Technical Service Bulletin (TSB)
Interior Rear Facing Camera Bezel is Loose and or Falls Out of Headliner

REFERENCE:	TSB: 23-010-23 GROUP 23 - Body	Date:	January 24, 2023	REVISION:	-
VEHICLES AFFECTED:	2021 - 2023 (WL) Jeep Grand Cherokee NOTE: This bulletin applies to vehicles built on or before October 10, 2022 (MDH 1010XX) equipped with an Interior Rear Facing Camera (Sales Code XPR).			MARKET APPLICABILITY:	
				<input checked="" type="checkbox"/> NA	<input type="checkbox"/> CH
				<input checked="" type="checkbox"/> EE	<input checked="" type="checkbox"/> IAP
				<input checked="" type="checkbox"/> SA	<input checked="" type="checkbox"/> MEA
CUSTOMER SYMPTOM:	Customers may comment on the following:				
	<ul style="list-style-type: none"> The interior rear facing camera (FamCam) bezel, is loose and/or falls out of headliner (Fig. 1) . 				
CAUSE:	Low retention force caused by retention clips at low end of tolerance.

Fig. 3
Opening Retention Clip Nose And Gap

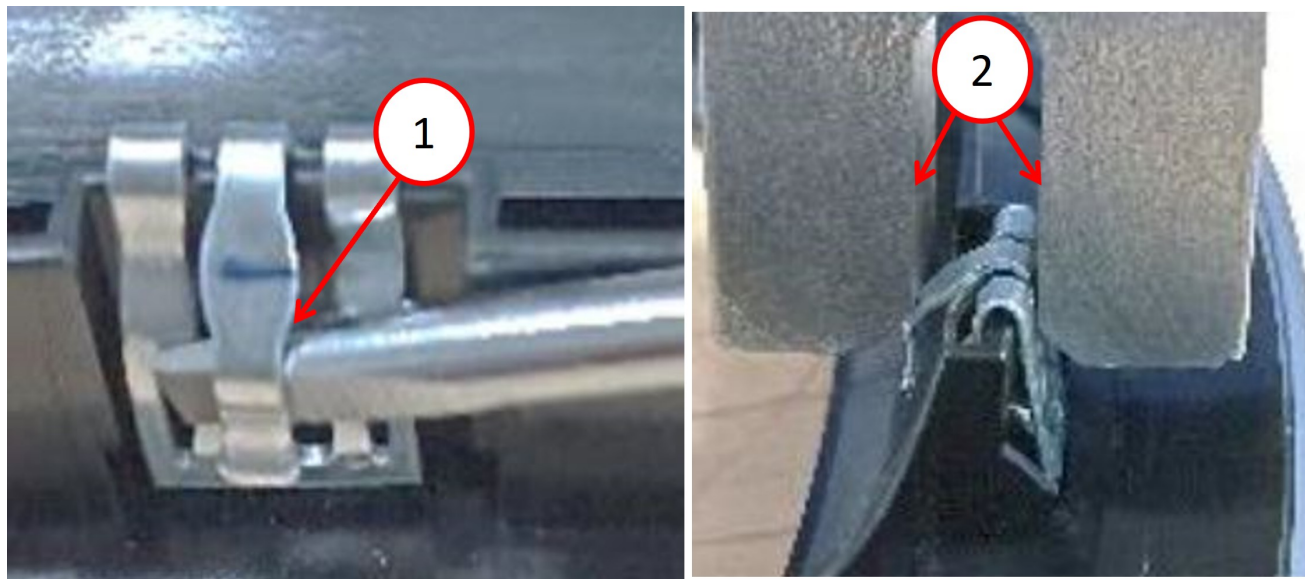
1. Remove the interior rear facing camera bezel from the headliner (Fig. 1) by pulling down on each corner of the bezel.
2. Using a flat blade tool, gently open the nose of the retaining clip out to 8 mm (0.31 in.) (Fig. 3) . **Perform this step on each of the four retaining clip noses.**

- 1 - Retention Clip
- 2 - 8 mm (0.31 in.) Clip Gap

3. Install the interior rear facing camera bezel on the headliner (Fig. 1) by pushing upward on each corner of the bezel. **Verify the bezel stays in place and is not loose.**
